From: Bratcher, Mike, EMNRD
Sent: Thursday, June 27, 2013 9:02 AM
To: 'Bruce Baker'; mburton@blm.gov
Cc: 'Gary Wink'; hconder@rice-ecs.com
Subject: RE: Linn Energy Skelly Unit # 2

Vertical Sampling Lab Data

LINN ENERGY SKELLY UNIT

#2 AD

Cl- LAB DATA

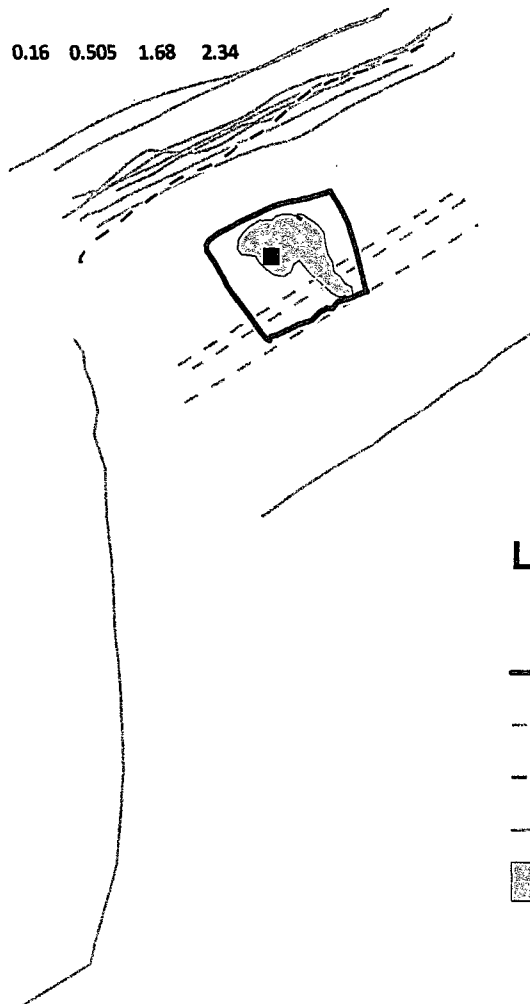
After reviewing the file on this site, I am reluctant to allow the clay barrier to be installed and then drill through it. That sort of defeats the purpose of the barrier. I don't recall if we discussed this or not, but I am assuming the 4' excavation has already been done? The release doesn't look like it covered a large surface area, but there is quite a column of fairly high numbers down to the 17' interval. In the past, we just always assumed there was no ground water in 17s-31e, but recently updated data in the OSE database shows three wells in section 33, drilled to 158', 60' and 55'. They were all allegedly drilled in January, 2010 but there is not much information to go with this data as far as depth to groundwater, so, to me, this data is more confusing than it is helpful. When you pull the sites up in Google, they are out in the middle of the pasture, no roads or apparent disturbance leading in and no indication of anything being there at all, so, who knows?

I agree with Mike. This should be delineated before closure. If need be, you can install a temporary road to get the truck in to complete delineation.
